DESIGN	DESIGN DRAWN BY		DART AEROSPACE HAWKESBURY, ONTARIO, CANAD			
I	CHECKE	D A	APPROVED A	DRAWING NO.	F	REV.	Α
I		#	#	DSI 9366	SHEET 1	OF	2
Ì	DATE			TITLE		SCA	LΕ
	07.02.07			CROSSTUBE SUPPORT CHANGE		N	rs
	Α		07.02.07	NEW ISSUE

DART SERVICE INSTRUCTION

TO AMEND INSTALLATION INSTRUCTIONS IIN-D206-667 Rev. C AND INSTRUCTIONS FOR CONTINUED AIRWORTHINESS ICA-D206-667 Rev. 2

REF. CANADIAN STC: SH01-5 REF. FAA STC: SR01304NY

FIGURE 1 - CROSSTUBE SUPPORT INSTALLATION ON D407-667-205

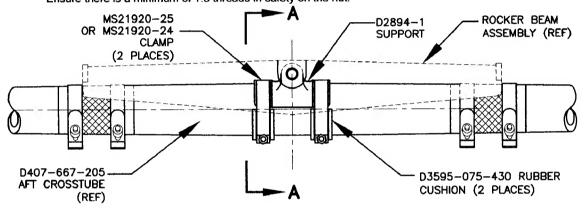
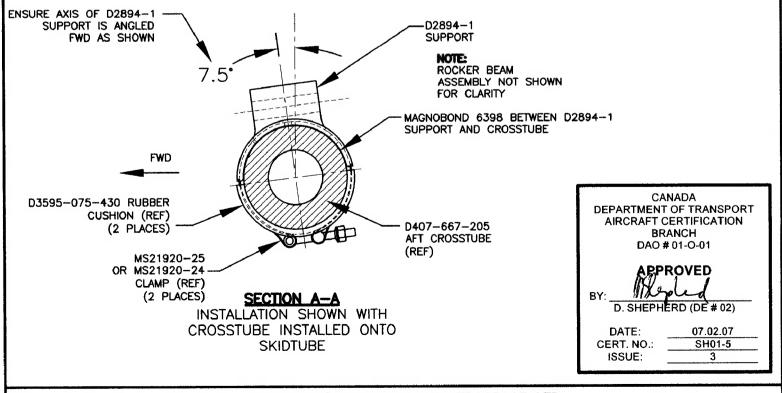
For D407-667-205 Aft Crosstubes at CHG 004 or later, the D2856-600-851 Abrasion Strip has been removed, the center D2894-1 Support has been bonded onto the crosstubes using Magnobond 6398 and D3595-075-430 Rubber Cushions have been installed underneath the MS21920-24/-25 Clamps. Amend Parts List of IIN-D206-667 Section 5 and ICA-D206-667 Section 32.8 as follows:

To prevent the center support from shifting on D407-667-205 Crosstubes at CHG 003 or earlier, the D2894-1 Support should be removed and re-installed as follows:

- 6) Apply a 0.03" to 0.06" thick layer of Magnobond 6398 underneath D2894-1 Support and re-install the Support on the crosstube as shown in Figure 1. Use rocker beam assembly to properly align the D2894-1 Support. Ensure the Rocker Beam Assembly can move freely without any friction with other parts. Position and secure the D2894-1 Support on the crosstube using MS21920-24/-25 Clamps. Install a D3595-075-430 Rubber Cushion underneath each MS21920-24/-25 Clamp. Torque clamps 80-100 in-lb. Let the D407-667-205 Crosstube Assembly cure before reinstalling the crosstube on the aircraft.

Note: The MS21920-24/-25 clamps are interchangeable to accommodate varying diameters. Ensure there is a minimum of 1.5 threads in safety on the nuts.

- 1) Follow section 32.1 of ICA-D206-667 for the removal of the crosstubes from the helicopter.
- 2) Remove the qty(2) MS21920-24 Clamps from the crosstube that fasten the D2894-1 Supports to the crosstube.

- 3) Remove the D2856-600-851 Abrasion Strip from the crosstube per section 32.5 of ICA-D206-667.
- 4) Inspect the crosstube surface underneath the support for corrosion and mechanical damage per items 5.3.1 and 5.3.2 of the 300 hour inspection. Repair damage within acceptable limits per item 5.3.3 of the 300 hour inspection. Touch up finish per item 5.3.9 of 300 hour inspection.

- 5) Abrade area to which support will be applied with 400 grit sandpaper. Saturate a clean cloth with MEK or 4105S Wash'n'Wipe Degreaser or equivalent and wipe area until there is no residue.

- 7) Re-install the D407-667-205 crosstube per Section 32.2 of ICA-D206-667.
